POWERTECH (USA) Inc.

June 13, 2012

Re: Additional Regional Meteorological Data; Powertech (USA) Inc.'s Proposed Dewey-Burdock
Project; Docket No. 40-9075

**Addendum to
TR RAI Response 2.5-1(c)**

Figure TR RAI 2.5-1c-3 Revised: Newcastle Wind Speed Correlation

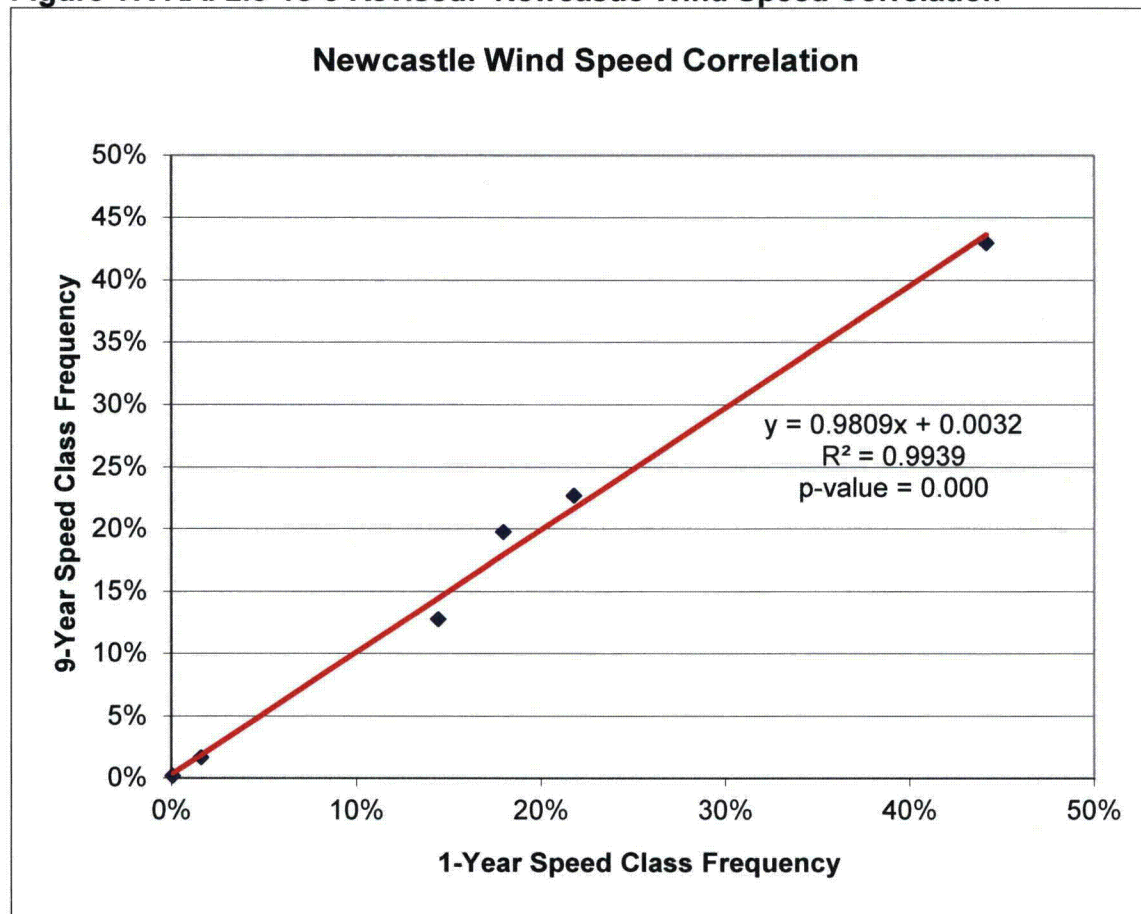
Figures TR RAI 2.5-1c-3 and TR RAI 2.5-1c-4 have been enhanced to show the p-value associated with each regression analysis. The R^2 value, or coefficient of determination, provides a measure of how well the baseline-year wind speed and direction distributions match (and therefore predict) the long-term wind speed and direction distributions. An R^2 value of 1 would indicate a perfect match between the two time periods. In this case, the short and long-term wind data distributions would be identical and therefore interchangeable. An R^2 value of 0.90 or higher indicates a very strong correlation between the short and long-term distributions.

The wind speed correlation graph in Figure TR RAI 2.5-1c-3 Revised was generated in Microsoft Excel. The following output from MiniTab, a statistical software package, corroborates the R^2 value obtained in Excel and displays the p-value of 0.000.

Figure TR RAI 2.5-1c-4 Revised: Newcastle Wind Direction Correlation

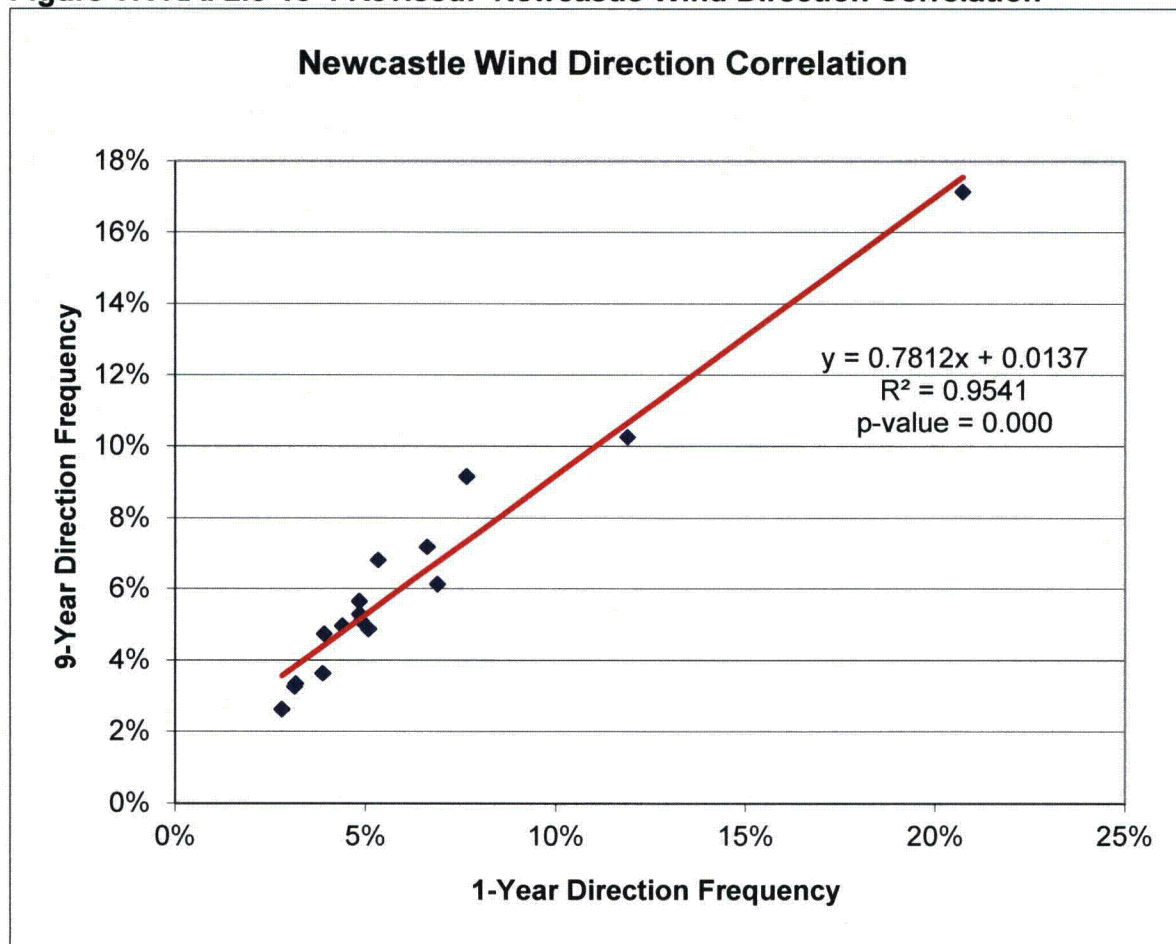
The wind direction correlation graph in Figure TR RAI 2.5-1c-4 Revised was generated in Microsoft Excel. The following output from MiniTab, a statistical software package, corroborates the R^2 value obtained in Excel and displays the p-value of 0.000.

Figure 3 Revised – Dry Fork 1995-2009 95% Confidence Interval

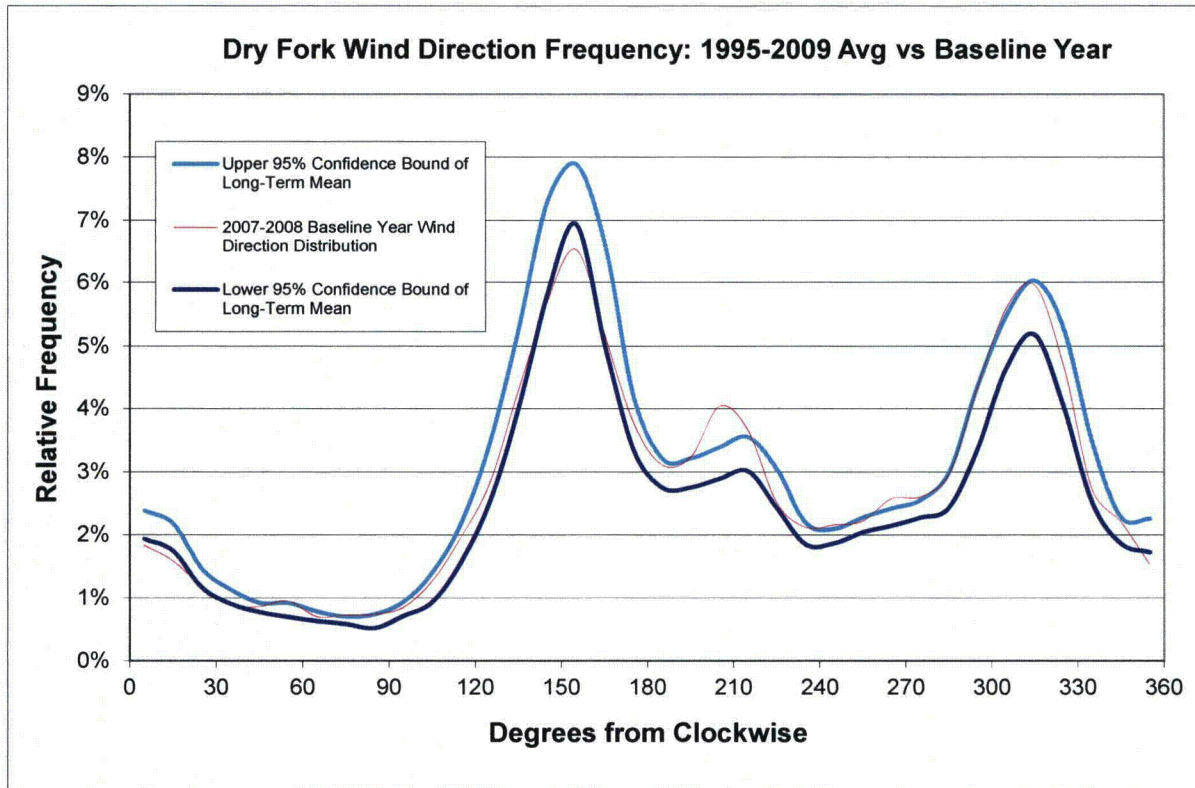
The following figures have been revised to reflect the Dewey-Burdock baseline monitoring year as the source of short-term wind direction data. In addition, the linear regression analyses are graphed with basic statistical parameters (including ANOVA and p-value) listed below each graph. As noted in Appendix 2.5-E, poor data resolution offered by the NWS may weaken the Gillette wind direction frequency correlation. Also, the Buckskin correlation is compromised by the meteorological station move in spring 2008 (near, but not at the end of the Dewey-Burdock baseline monitoring year). In both cases, however, unique site signatures and strong correlations between long-term and baseline-year direction frequencies are still apparent.

Figure 7 Revised – Dry Fork Regression Analysis

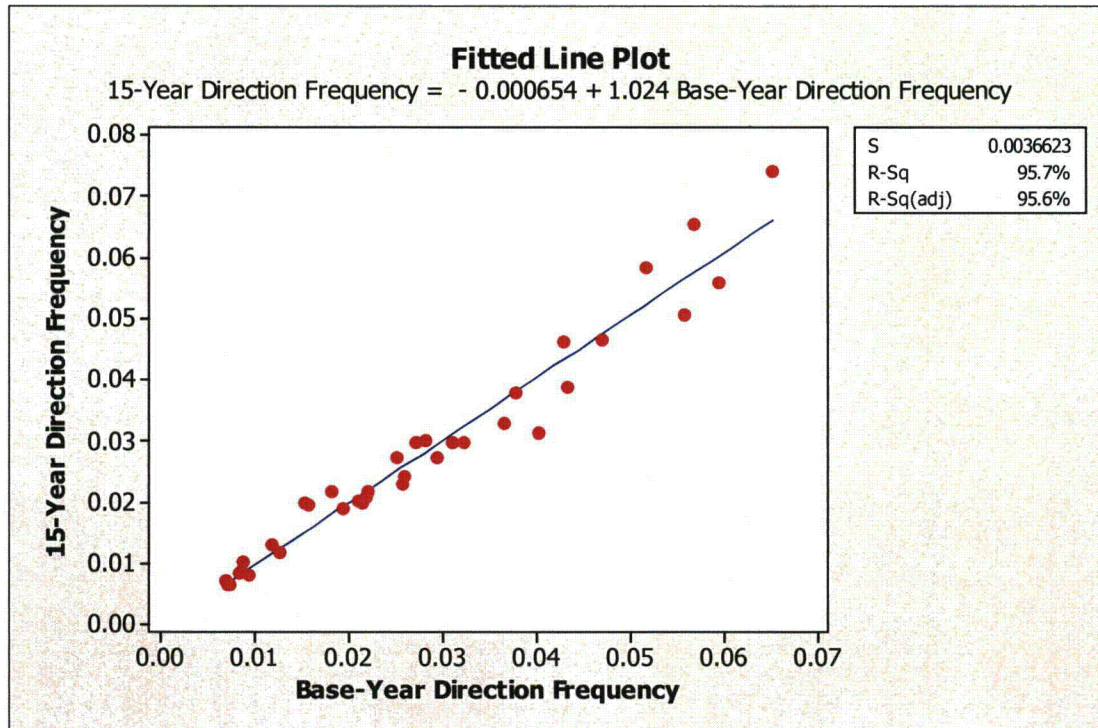
15-Year Direction Frequency = - 0.00065 + 1.02 Base-Year Direction Frequency

Figure 12 Revised – Antelope Regression Analysis

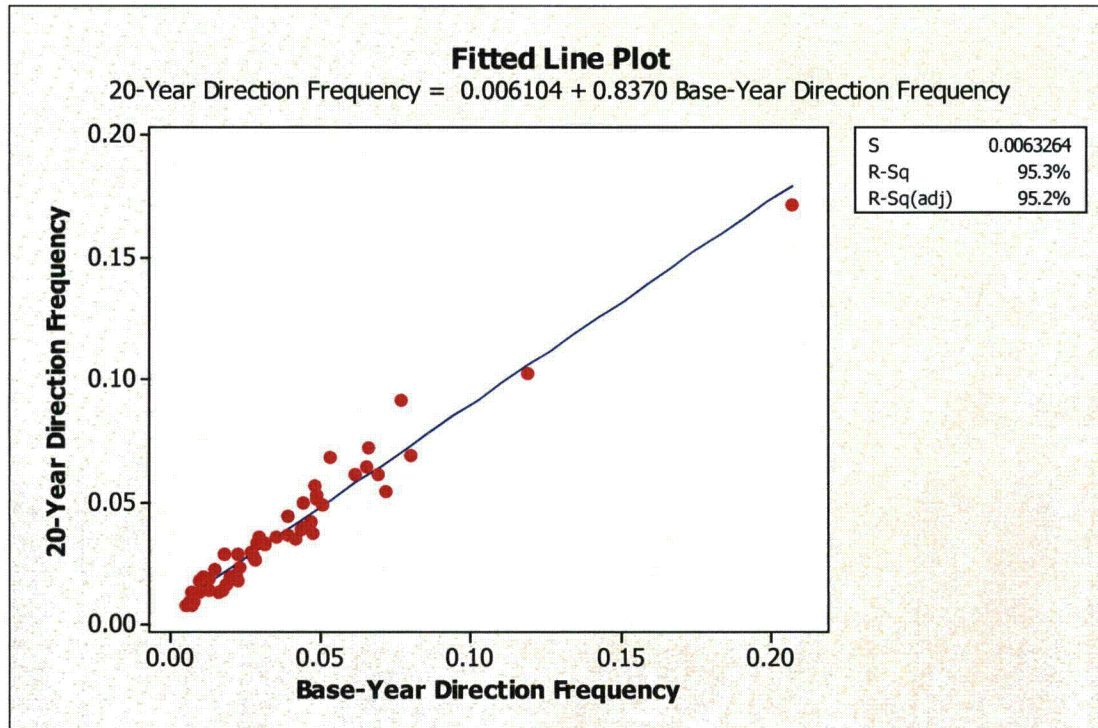
20-Year Direction Frequency = 0.00610 + 0.837 Base-Year Direction Frequency

Figure 14 Revised – Gillette Regression Analysis

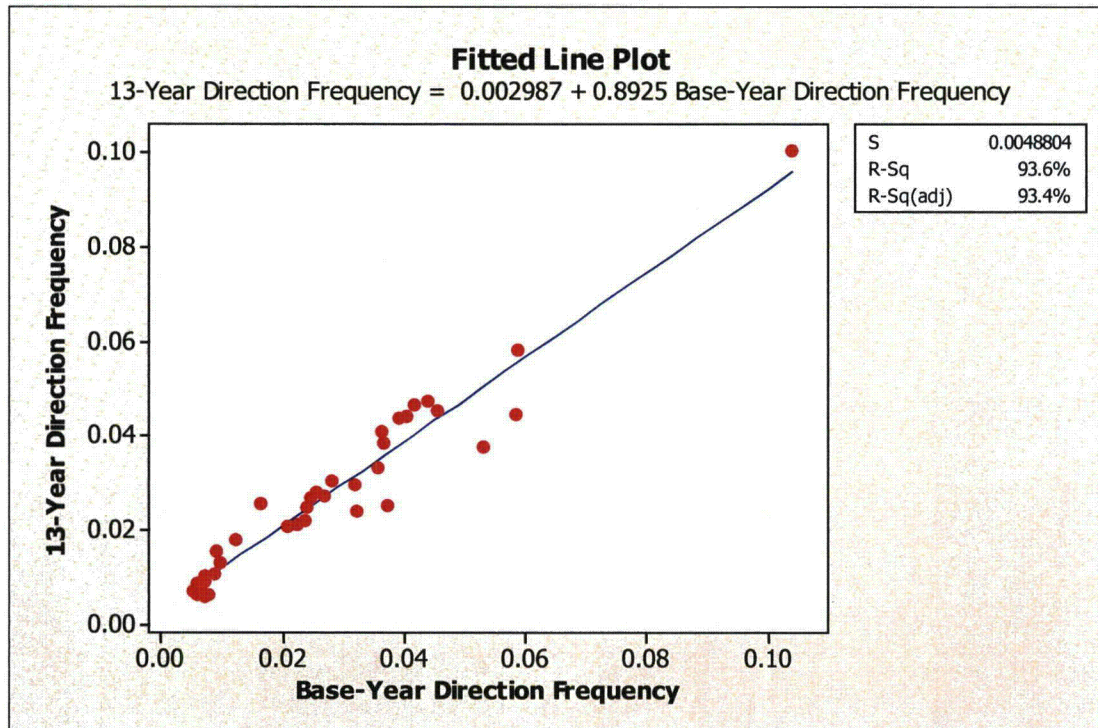
13-Year Direction Frequency = 0.00299 + 0.892 Base-Year Direction Frequency
